5.6 Variation to Clause 4.6 - Exceptions to Development Standards

5.6.1: Height of Building Variation

RE: DA15/1475: Response to Councils Comments; 2 Hargrave Street, Kingswood.

Block Massing Analysis

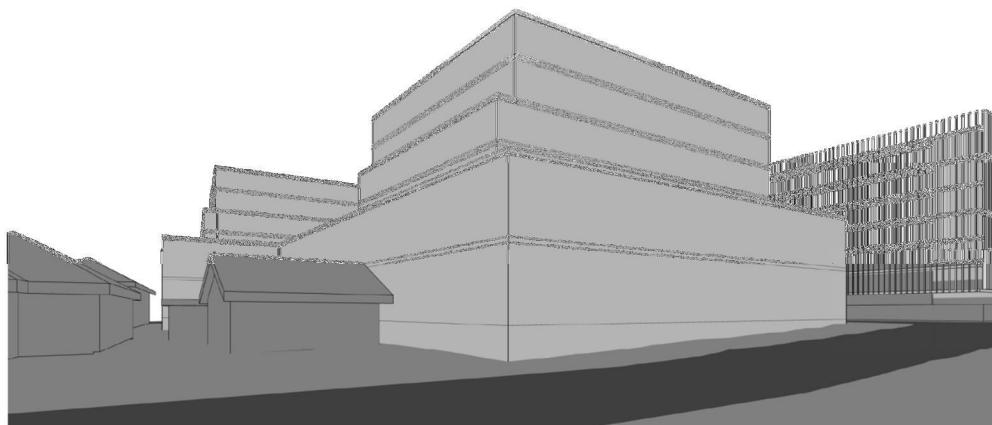
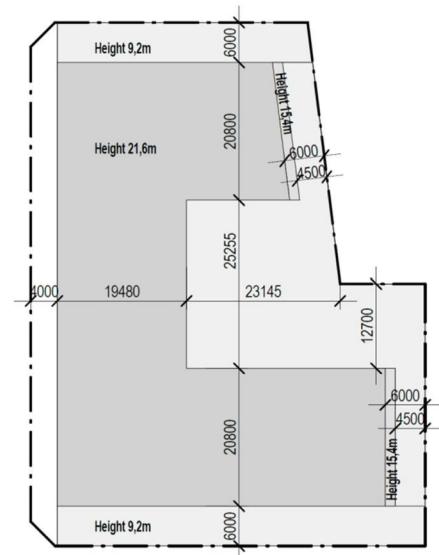
Council has requested additional justification of the proposed building height justifying that there are sufficient environmental planning grounds to justify contravening the development standard particularly something specific to the site and development rather than generic benefits (such as provision of jobs + housing stock). Accordingly, the Morson Group has prepared mock block study plans showing the comparison of the proposal scheme v that which could be achieved with a compliant scheme (21.6m in height and 3.5:1 FSR). In addition to principle LEP controls, the block study abided by key DCP principles as follows:

The block massing exercise demonstrates that a worse planning and design outcome could be achieved on the site via a '*complying scheme*' which abides by Councils planning controls for the Penrith Health and Education Precinct. The permissible envelope can be seen below:

Specifically the following key issues are raised with the compliant block envelope (which proposes a 3.5:1 FSR as opposed to the 3.13:1 FSR proposed by the DA).

Planning Issue	Detail/Impacts
<i>Communal Open Space</i>	<ul style="list-style-type: none"> - Significant reduction in communal open space within the central element of the development. - reduction of 118 sqm of communal open space to that proposed under the DA - Heating impacts (increased provision of hard stand materials) - Reduced solar access for public open space (given the reduction in separation).
<i>Eastern Interface (wall height)</i>	<ul style="list-style-type: none"> - Two storey wall heights built to eastern boundary for commercial use is permissible under the DCP. Significant amenity implication for the adjoining sites (hard stand wall approximately 7.5m high) - Poor design outcome for the surrounding precinct (sets negative design precedent) - Significant privacy issues between the site and 4-6 Hargraves Street and 25-27 Derby Street (strata titled building). podium level 2 storeys up with direct east and northern views over adjoining low density uses.

<i>Solar Impacts</i>	<ul style="list-style-type: none"> - Reduced access to solar during mid-winter for adjoining sites to the east (less than 2 hours winter solstice). - Increased solar impacts to the south (given form is built to boundary for first two levels consistent with the built form DCP controls). - Increased solar impacts to the site itself (form built to boundary at the northern edge).
<i>Internal Amenity</i>	<ul style="list-style-type: none"> - The internal amenity of the building would be compromised via the block modelling, in terms of building depth and width - Reduced common open space - Reduced eastern aspect for apartments (solar implications) - SEPP 65 building design implications (depth, cross ventilation etc).
<i>Architectural Form</i>	<ul style="list-style-type: none"> - Reduced indentation, modulation and articulation of building façade. the existing design provides façade breaks which improve the presence of the building and cross ventilation. - The block model shows a building built to boundary which presents as boxy and overly dense however which complies with key Council controls + DCP design guidelines - Reduced upper level setbacks to that currently proposed (NE and SE interface).

<i>SEPP 65/ADG compliance</i>	<ul style="list-style-type: none"> - Reduced separation for south and north facing balconies over the common open space - Reduced cross ventilation via a bulky form/larger building envelope. Less corner and cross over apartments. - Reduced solar access (south + north facing units over the courtyard) through reduced separation - It is believed a configuration of units within this envelope would struggle to meet the development controls of the ADG and SEPP 65 (cross ventilation, length of corridors).
<i>Reduced landscaping</i>	<ul style="list-style-type: none"> - Reduced site edge landscaping given first two levels would be built to boundary - negative streetscape implications (site edge landscaping limited to primary western frontage) - Increased heating of the site (concrete hardstand GBA increase).
<i>Visual Impacts</i>	<ul style="list-style-type: none"> - Block modelling presents as overbearing to the surrounding context. Reduced height on the western interface further highlights the presence of the existing hospital carpark which is a visual eyesore. - lower height with a larger footprint sets a negative precedent for development in the area with reduced regard to amenity, solar access, provision of publically appealing landscaping and an unappealing architectural presence.

<i>Urban Design</i>	<ul style="list-style-type: none"> - block model scheme disregards key urban design principles which encourage larger forms on key corner sites - provision of a denser envelope with less height variation provides a negative urban design outcome for a key site with three street frontages in Kingswood. - Architectural form appears bland and unmodulated.
